**EXPLANATION OF SIGNIFICANT DIFFERENCES  
TO THE REVISION.1.1 RECORD OF DECISION  
FOR  
THE OLD F-AREA SEEPAGE BASIN**

This Explanation of Significant Differences (ESD) is being issued by the Department of Energy (DOE), the lead agency for the Savannah River Site, with concurrence by the Environmental Protection Agency-Region IV (EPA) and South Carolina Department of Health and Environmental Control (SCDHEC) to announce changes in the remedial decision selected for the Old F-Area Seepage Basin (OFASB) waste unit. The waste unit is located northwest of the center of the Savannah River Site (SRS), in Aiken, South Carolina. The original remedy includes removal of contaminated vegetation from the basin and overflow ditchline, chipping the vegetation, and transporting the chipped vegetation off-unit for disposal. This ESD provides the rationale for disposing of the chipped vegetation on-unit. The result of this remedy change would: (1) reduce the overall cost of the remedial action by eliminating the costs for additional vegetation handling, transportation and disposal off-unit; (2) eliminate the unnecessary exposure risk to the workers handling, transporting, and unloading the veget

# ATTACHMENT A SKETCH SHOWING THE CROSS-SECTION OF THE COVER SYSTEM OVER OFASB

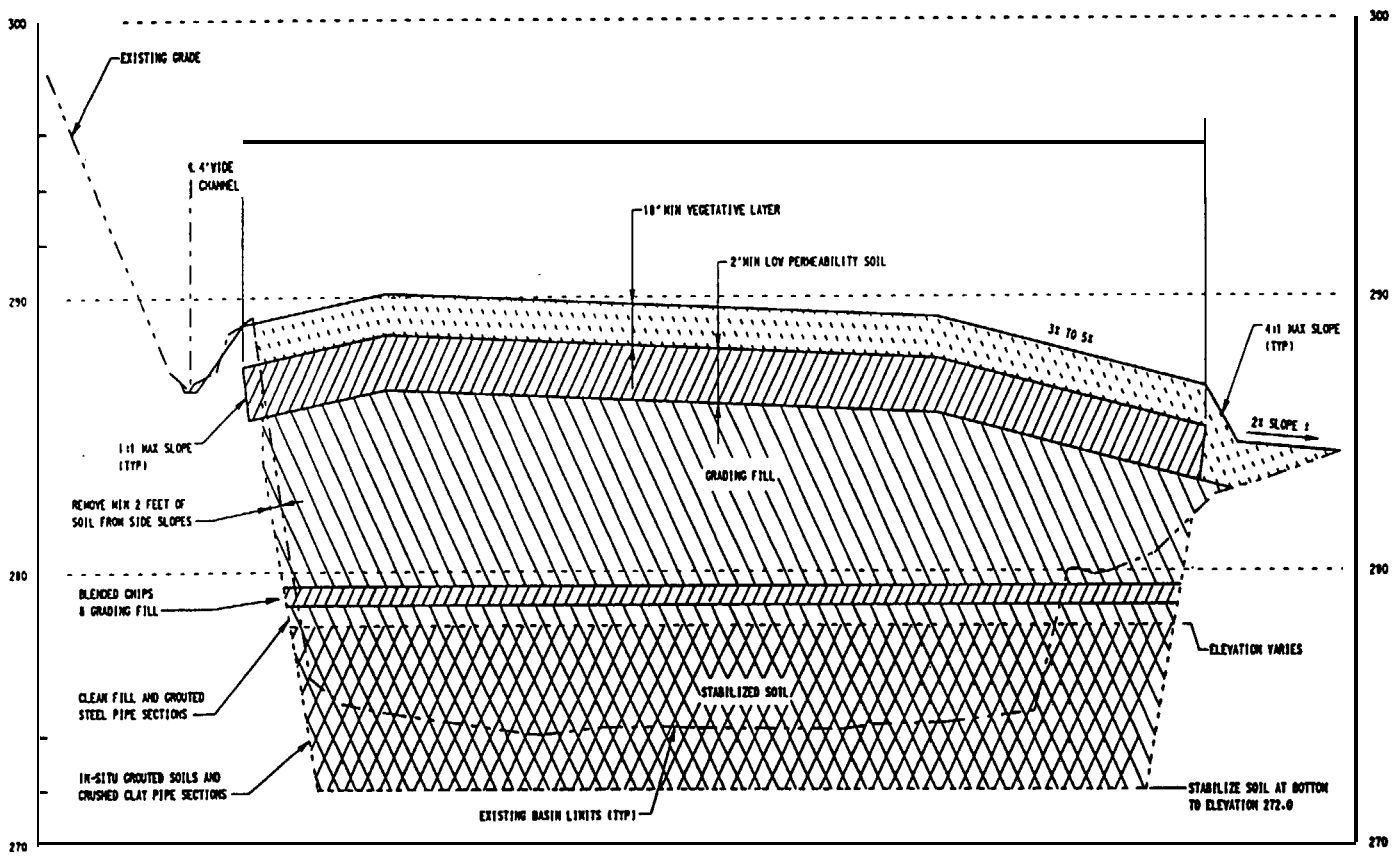
The change in the originally approved remedy is to dispose of the vegetation from the basin and overflow ditchline on-unit in lieu of off-unit. All other remedial action remedies remain unchanged. The chipped vegetation is currently stored on-unit. Prior to and during production grouting of the basin soils the chipped vegetation will be handled and stored in accordance with established SRS requirements. After completion of grouting, the chipped vegetation will be placed on top of the first clean, compacted, soil fill layer placed over the in-situ grouted soils. The chipped vegetation (approximately 285 cubic yards) will be blended into the second lift of grading fill. The volume of the chips will be limited to approximately 15% of soil volume and will be uniformly spread over the compacted lift of grading fill. The blended material will be compacted prior to placement of additional fill material. Clean fill material will continue to be compacted in-place until the proper grade for a low permeability cap has been obtained. A low permeability engineered soil cap would then be constructed over the basin area to minimize surface infiltration and reduce the potential for contamination migration. This method of chip disposal will minimize potential of settlement especially uneven settlement that could result in cracking of the soil cover system. Attachment A shows a typical cross section of the disposed chips and associated constructed layers required to complete the basin closure.

The on-unit disposal of chipped vegetation will be constructed to have approximately four (4) feet of clean soil over the top of the blended vegetation/soil compacted mixture. An analysis was performed to calculate the shielding effect of soil cover against Cesium -137, a source for gamma radiation, for H-Retention Basin (ECSD-SGS-95-0317, dated July 13, 1995). The calculations show that a 2 to 3 ft soil cover provides adequate safeguard against any external exposure from the gamma radiation source. For the OFASB, the major contaminants include Cesium- 137 and Mercury. Cesium concentrations in the soil at OFASB are considerably less than the value analyzed for H-Retention Basin (1,345 pCi/g vs. 33,000 pCi/g). The radiological contamination identified in the chipped vegetation (e.g. Cesium 2.89 pCi/g) is much lower than the contamination levels detected in the OFASB soils. Hence, the proposed remedy for the disposition of chipped vegetation placed over the grouted matrix in a soil mixture will be effective in eliminating the direct radiation exposure hazards associated with the on-unit worker.

A low permeability engineered soil cap with a minimum thickness of 2 feet of compacted low-hydraulic conductivity soil (in-place saturated hydraulic conductivity of  $1 \times 10^{-5}$  cm/sec or less) is installed over the vegetation/soil mixture and compacted clean fill material. The cap will also have an upper surface with a slope to promote surface runoff and minimize surface erosion. A vegetative soil layer will be placed over the low permeability layer to support grass growth and will have the ability to survive and function with little or no maintenance. The surface slope will also promote runoff and minimize surface erosion. The design of this cap both reduces the risks associated with direct radiation exposure and minimizes future potential migration of contaminants to the groundwater.
